## Metro Inner Development Assessment Panel Agenda

**Meeting Date and Time:** Wednesday, 26 June 2024; 9.30am  
**Meeting Number:** MIDAP/20  
**Meeting Venue:** 140 William Street, Perth  
**Public Observing:** Online

1. Declarations of Due Consideration
2. Disclosure of Interests
3. Form 1 DAP Applications
4. Form 2 DAP Applications
  - 4.1 Lot 1 (No.59) Blinco Street Fremantle - 12 Grouped Dwellings - DAP/23/02454
5. Section 31 SAT Reconsiderations

1 EAST ELEVATION  
A02-101 1 : 100

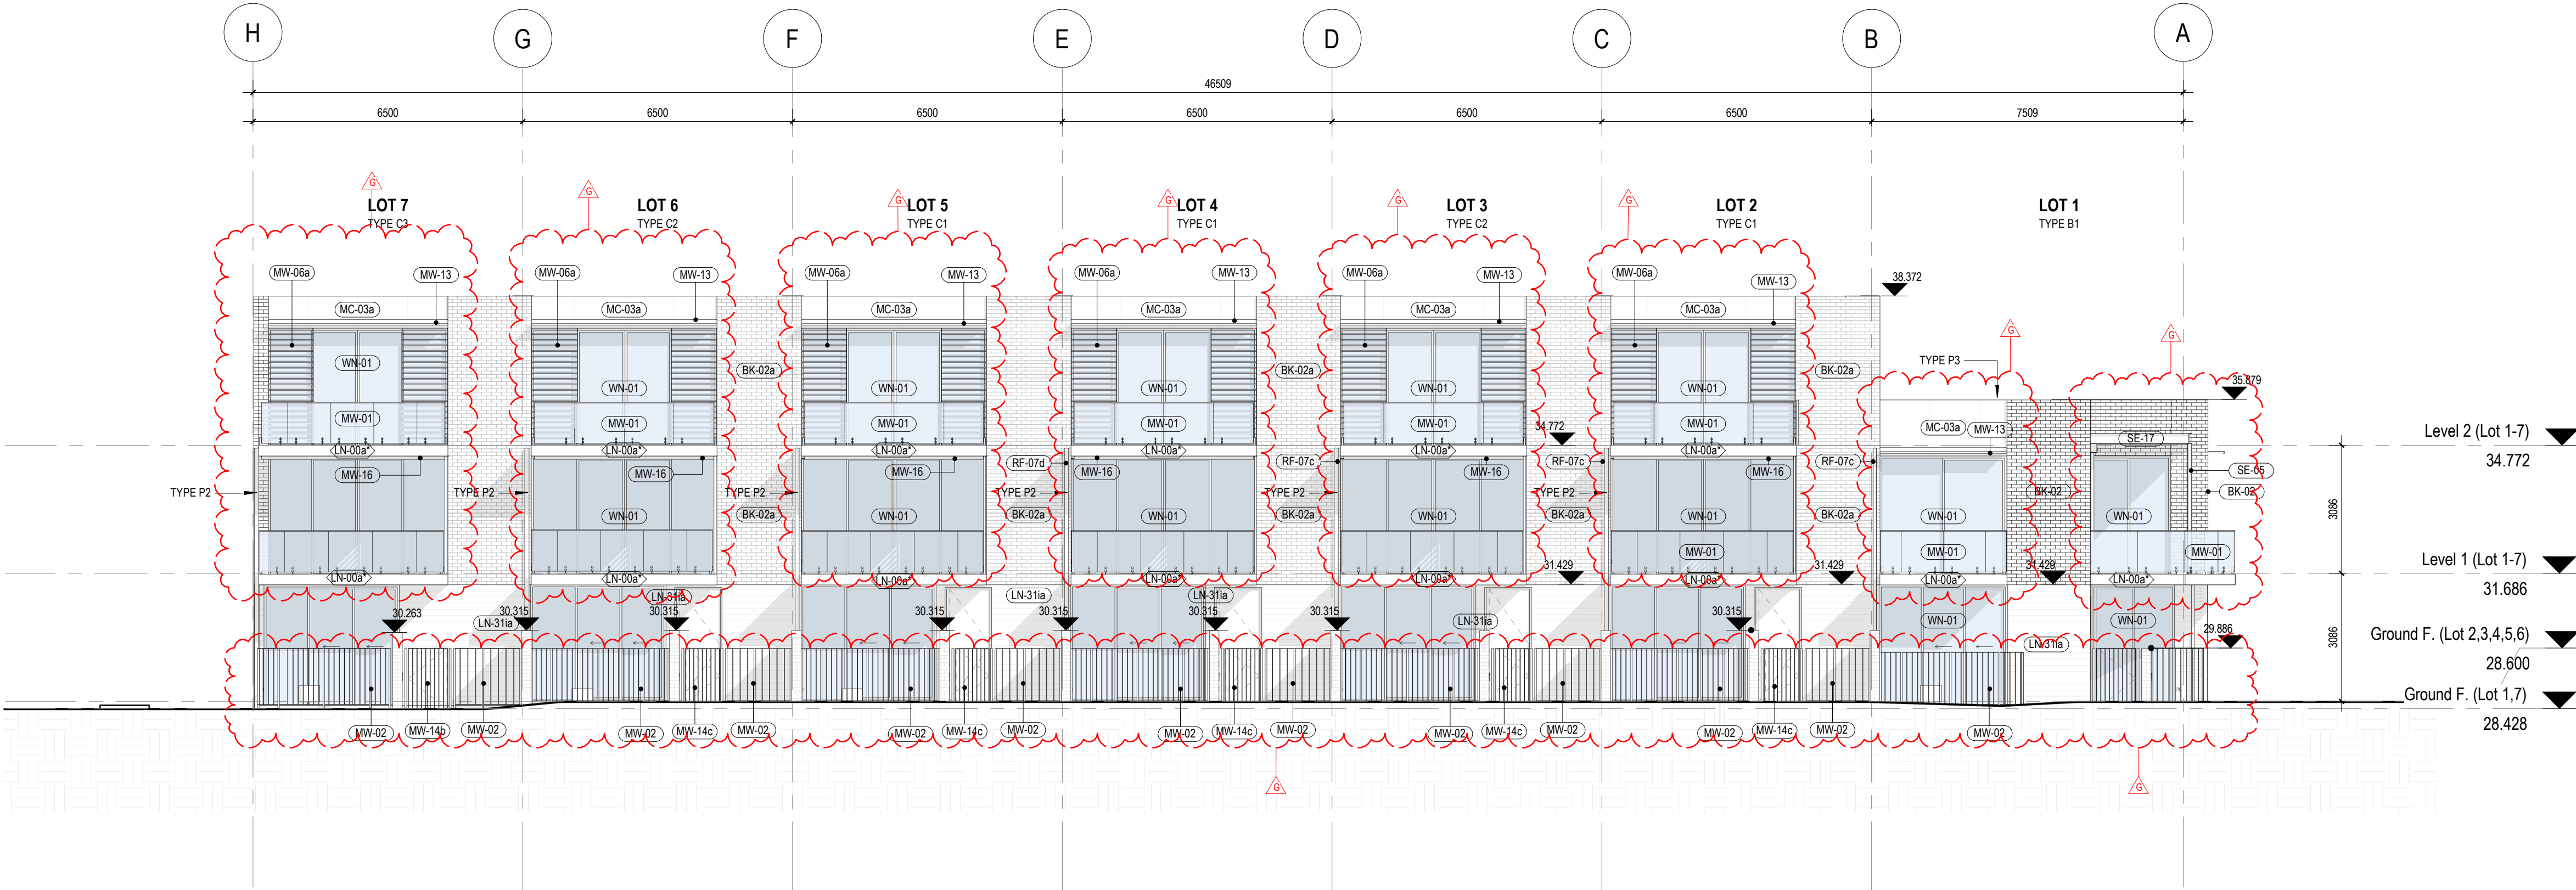
*A positive change on the eastern elevation is the lowering of the second-floor canopy to above opening head height to assist with shading of internal rooms. Consider extending the shade canopy to additionally protect the second-floor balcony from strong summer sun.*
